**Project #21-012
Quayle Meadows Subdivision Phase II
Located at ~ 500 West 1800 North**

REPORT SUMMARY...

Project Name: Quayle Meadows Subdivision Phase II
Proponent/Owner: Roger C. Jones / Doris & John Jones Fam. Trust
Project Address: Approximately 500 West 1800 North
Request: 27-Lot Subdivision Permit
Current Zoning: NR-6
Date of Hearing: March 11, 2021
Type of Action: Quasi-Judicial
Submitted By: Russ Holley, Senior Planner

QUAYLE MEADOWS SUBDIVISION PHASE 2

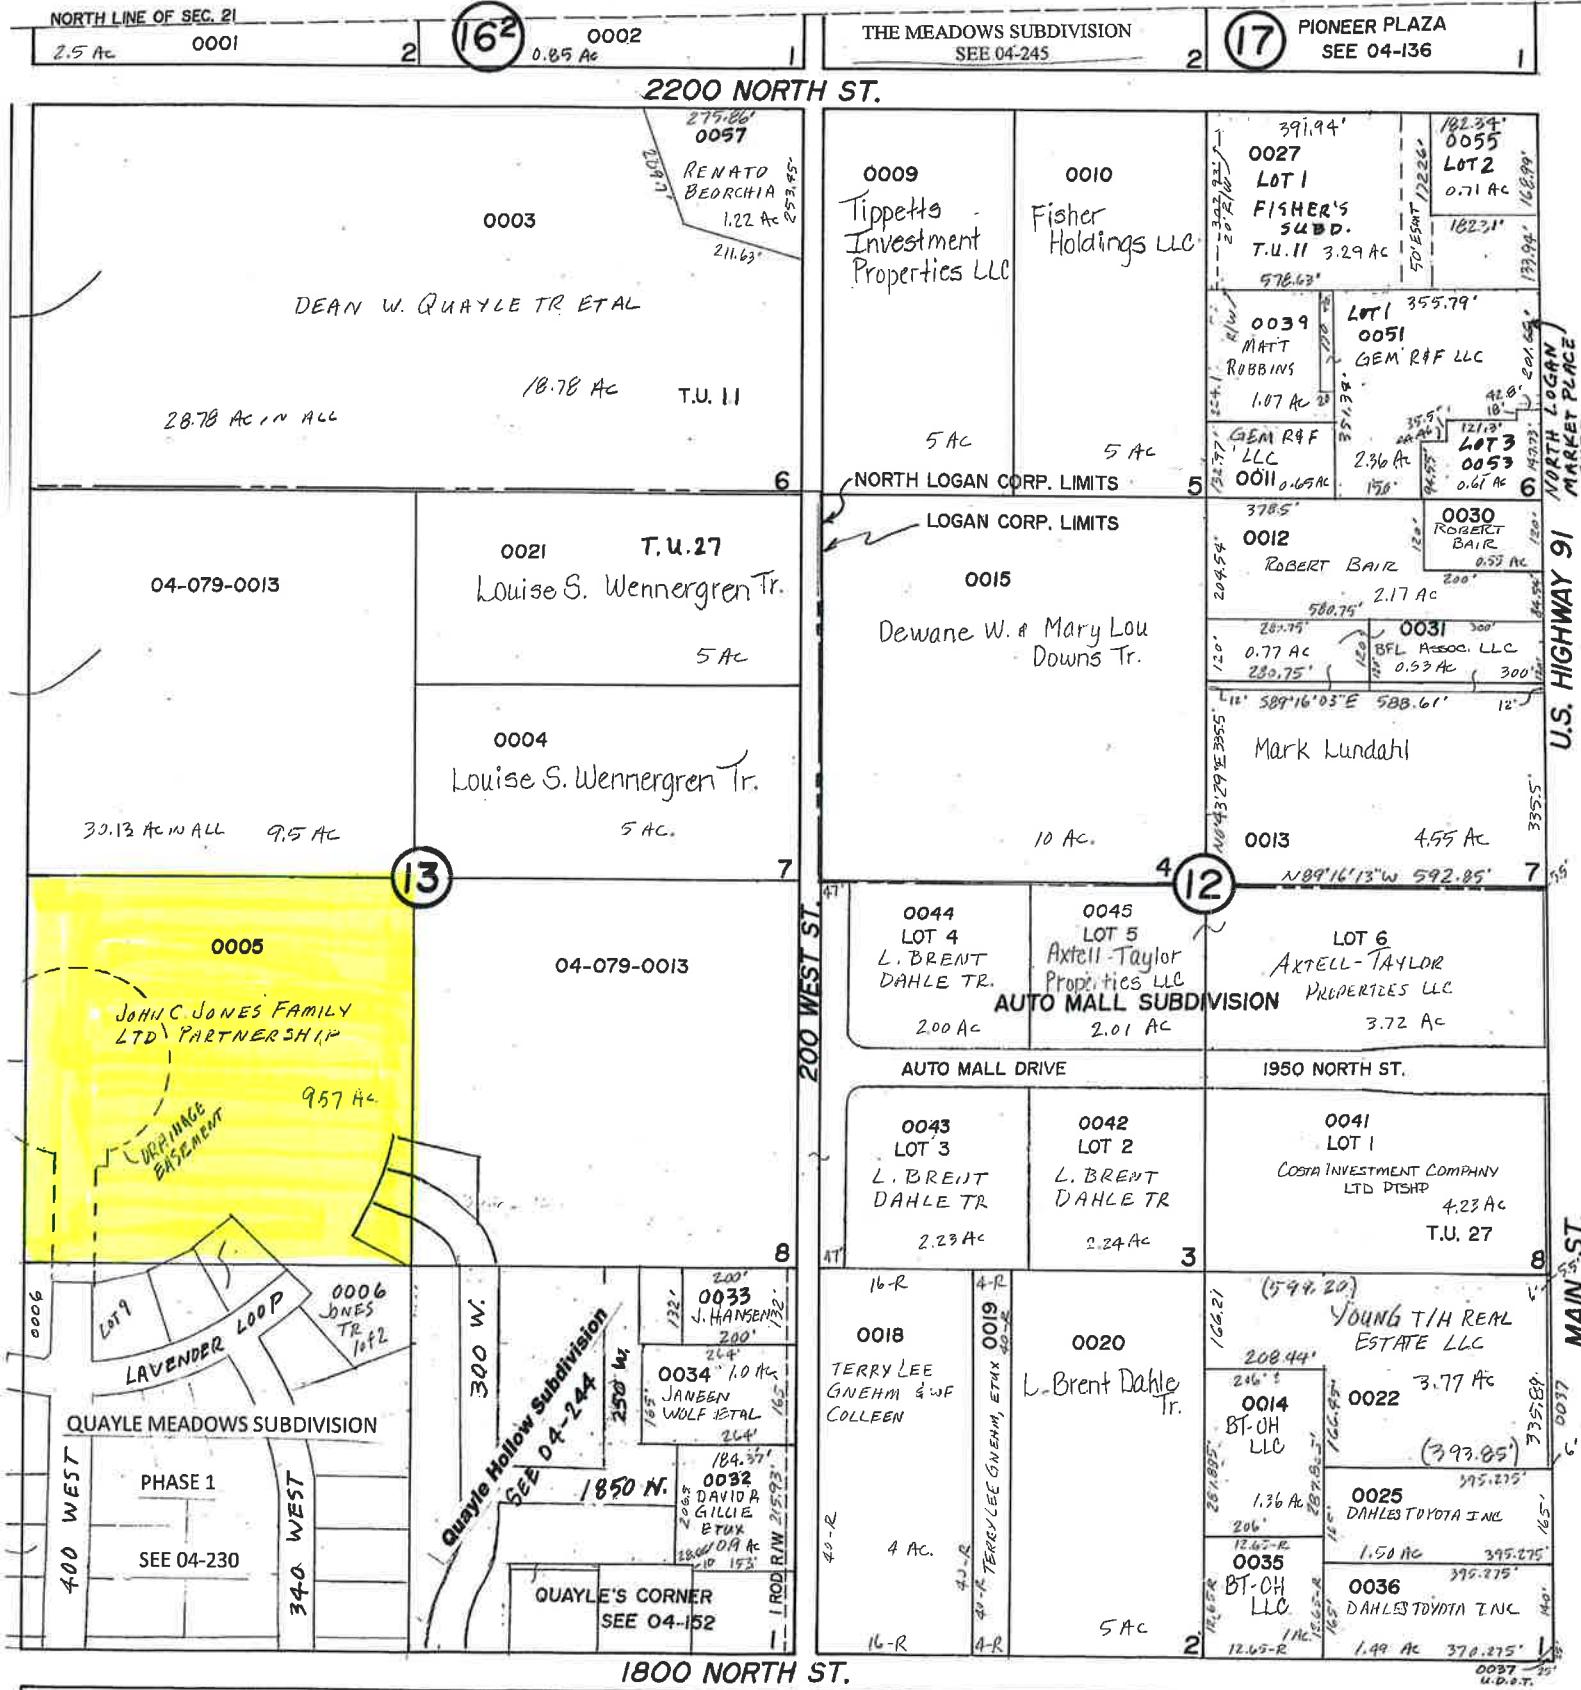
- Pipe canal along the east side of development (along 200 West) and widen 200 West to a 66' ROW. All canal improvements will need to be approved in writing by the canal company.

- Dedicate a 60' right of way from the west end of 1830 North to the west property line of parcel 04-079-0021. Construction of the road extension shall be done by City or as part of the next phase of construction.

- Show remainder parcel of 04-079-0021 between Lots 36, 46 and 47 and parcel 04-079-0020 on subdivision plat.
